Solicitation Amendment 007

ADDENDUM #4

PACIFIC RIM NATIONAL PARK
WASHROOM BUILDINGS
TOFINO, B.C.
Project No: R.078666.001

ADDENDUM #5

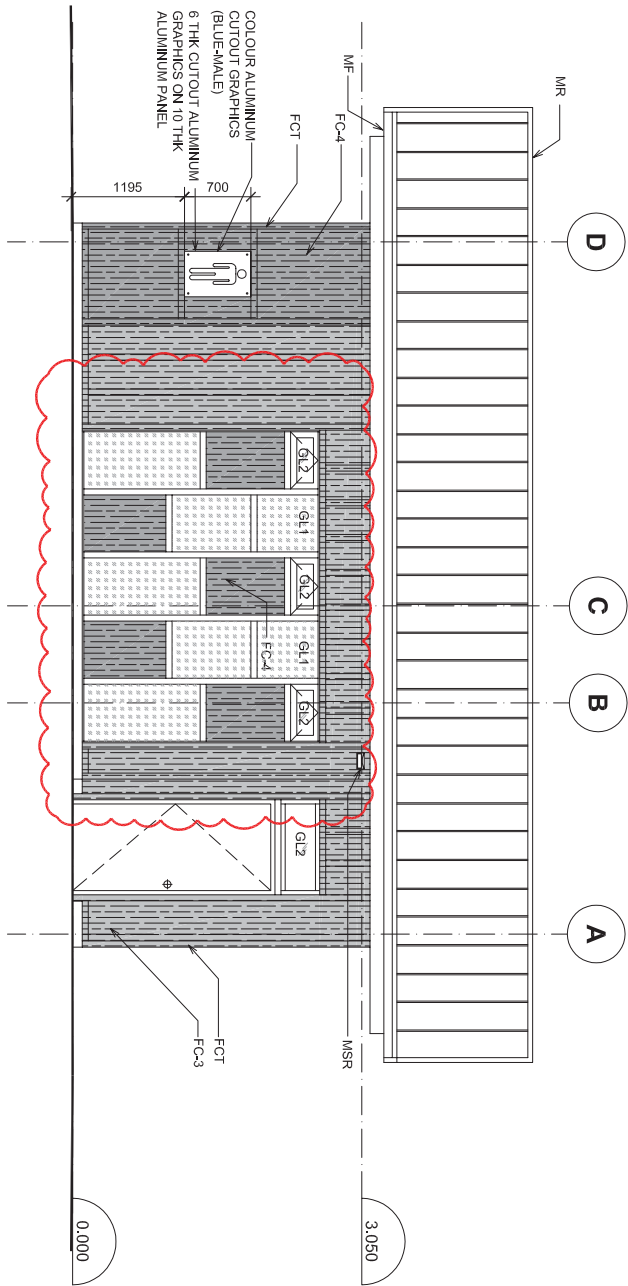
Q9. Change Room Benches – please provide details

A9. Refer to Specification 10 28 10, item 2.3.13.

3
A-3.4
1 : 50
WICKANINNISH BEACH
BUILDING ELEVATION - 3

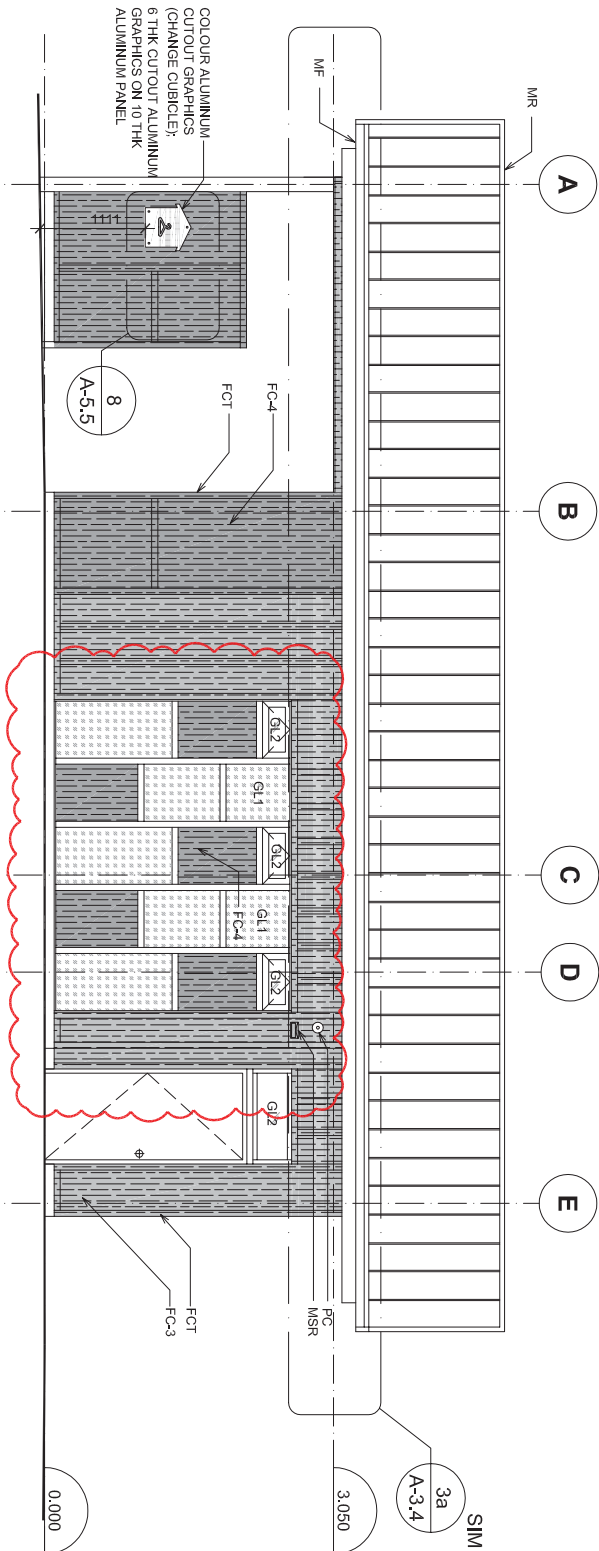
- Q1. Please clarify which area is glass and what is panel for the curtain wall frames. The typical interior elevations #1 & 7 on A-6.0, the layout does not match the exterior elevations.

- A1. Refer to attached drawings AD-2.5-1, AD-2.5-2, AD-3.4-1, AD-3.4-2, AD-4.5-1, AD-4.5-2, and AD-6.0-1.
- Q2. During each phase of construction, we are planning to demolish all three buildings at once, so none of the three buildings will be operational during the October to March time period. Please confirm this is the intent.
